DRIP GUARD ADDITION - FRONT COMPARTMENT

Prevost vehicles

On the vehicles affected by this bulletin, bus washing operations can result in water dripping into the front service compartment. Add a drip guard above the entrance door valve.

Figure 3: Loosen left screw

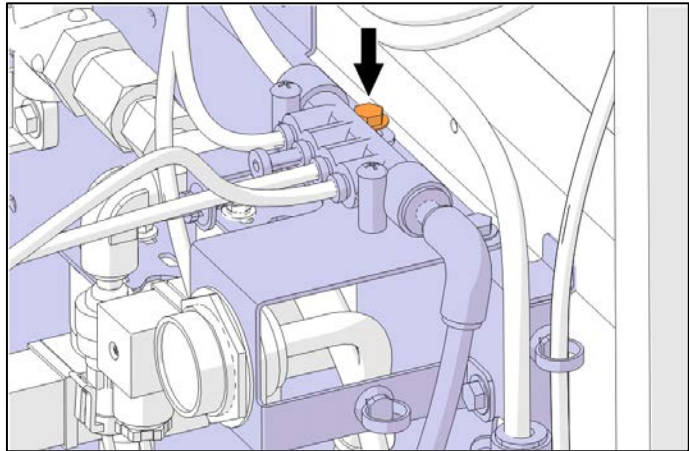
4. On the air distributor mounting bracket, loosen the left screw a few turns.

Figure 4: Slide in

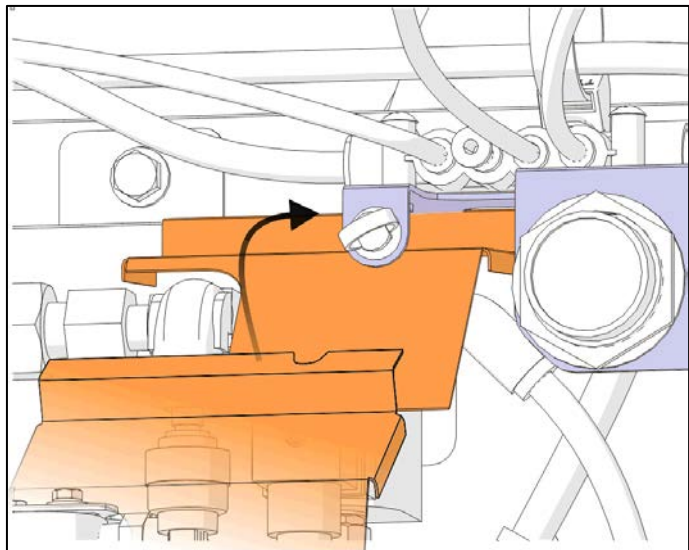
5. Insert drip guard under distributor mounting bracket.

Figure 5: Tighten screw

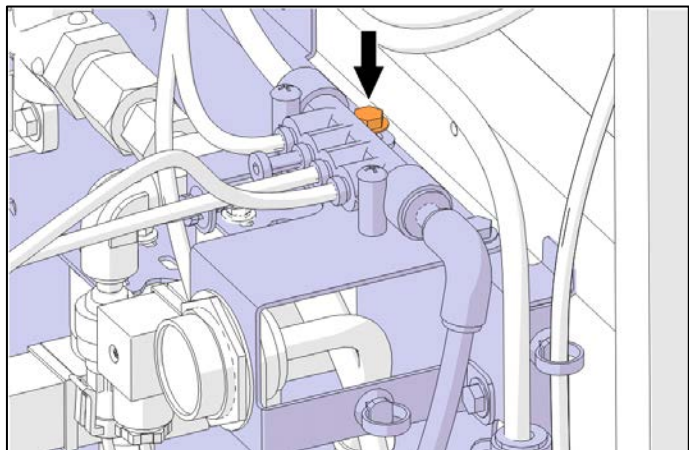
6. Tighten screw to **7 lb-ft.**
